LEE'S SUMMIT
MISSOURI
Development Services Department

Development Services Staff Report

File Number	PL2022-074 – REZONING from AG to RP-4 and PRELIMINARY DEVELOPMENT PLAN – Tristar at Lee's Summit
Applicant	Engineering Solutions, LLC
Property Address	Approximately 54 acres located on the east side of Old 291 Hwy approximately 1/2 mile north of M-150 Hwy
Planning Commission Date Heard by	April 28, 2022 Planning Commission and City Council
Analyst	C. Shannon McGuire, Planner
Checked By	Hector Soto, Jr., AICP, Senior Planner Kent Monter, PE, Development Engineering Manager

Comprehensive Plan

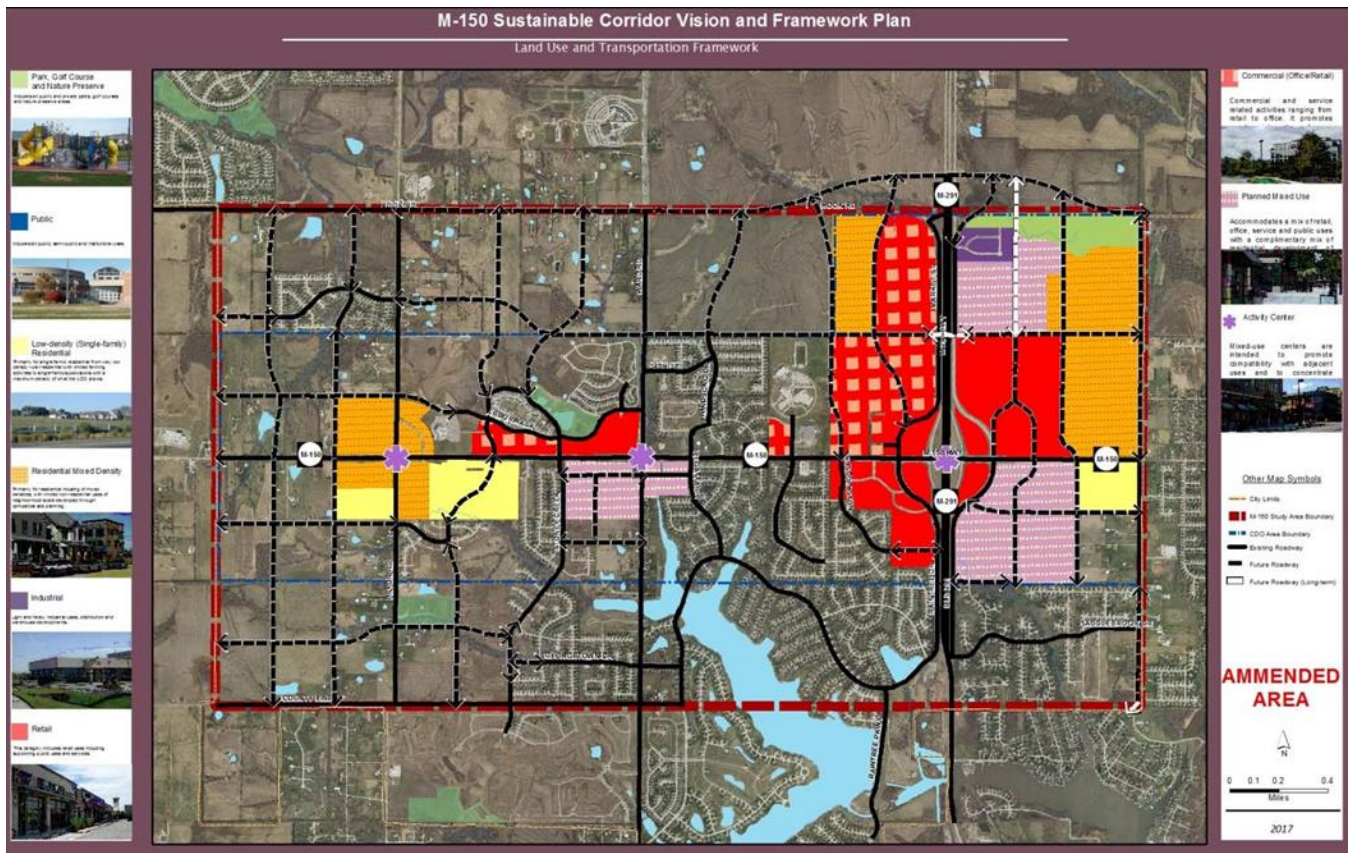
The 2021 Ignite Comprehensive Plan land use map identifies the subject site as Residential Category 1. The subject plan is inconsistent with Comprehensive Plan as the proposed land use would be classified as Residential Category 2. The proposed land use is not out of character for the surrounding area. A portion of the abutting vacant property to the south is currently designated as Residential Category 2, as is the southern section of the adjacent Cobey Creek residential subdivision.

While the proposed plan is inconsistent with the land use recommended by the Comprehensive Plan, it is consistent with the recommended land use as outlined in M-150 Corridor Development Overlay (CDO) District. The land use map in the M-150 Sustainable Corridor Vision and Framework Plan identifies this area as Residential Mixed Density.
